Access Compliance Report

Public Rights-of-Way

Intersection ID: 12160	Main Street: E_9TH_ST	Cross Street: N_BREVARD_ST	Location: W
ADA ID: 7E794E51F163	Ramp Type: Perp	Initial Pass/Fail: Fail	Overall Compliance: No
Severity Score: 12.5			
Codes/Mitigation Info/Possible Solution		Field Measurements/Component Compliance

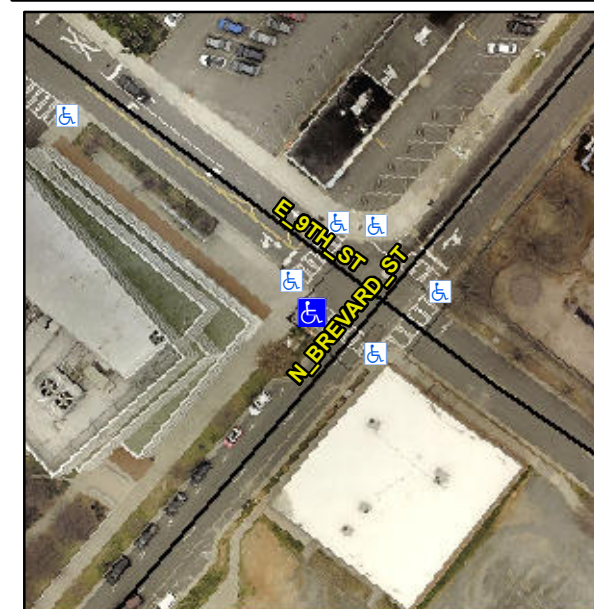
Not Found, R304.2.2

Compliance	Description	Data	Compliance	Description	Data
N/A	Ramp Length (in)	72.0	No	Ramp Slope (%)	9.3
Yes	Ramp Width (in)	48.0	Yes	Ramp XSlope (%)	0.3
N/A	Flare Type LT	N/A	N/A	Flare Type RT	N/A
N/A	Flare Slope LT (%)	N/A	N/A	Flare Slope RT (%)	N/A
N/A	Flare Traversable LT?	N/A	N/A	Flare Traversable RT?	N/A
N/A	Landing Length (in)	N/A	N/A	DWS Provided?	N/A
N/A	Landing Width (in)	N/A	N/A	DWS Contrast?	N/A
N/A	Landing Slope (%)	N/A	N/A	DWS Length (in)	N/A
N/A	Landing X Slope (%)	N/A	N/A	DWS Full Width?	N/A
N/A	Landing Curb? (Y/N)	N/A	N/A	DWS Offset (in)	N/A
N/A	Shared Landing?	N/A			
N/A	Gutter Ponding?	N/A	N/A	Gutter Slope (%)	N/A
N/A	Gutter Lip Ht (in)	N/A	N/A	Gutter X Slope (%)	N/A
N/A	Painted X Walk1?	Yes	N/A	Painted X Walk2?	N/A
	X Walk 1 Direction	To SE		X Walk 2 Direction	N/A
N/A	X Walk 1 Width (in)	104.0	N/A	X Walk 2 Width (in)	N/A
	X Walk 1 Slope (%)	1.2		X Walk 2 Slope (%)	N/A
	X Walk 1 X Slope (%)	3.2		X Walk 2 X Slope (%)	N/A

Remove & Replace Entire Ramp.
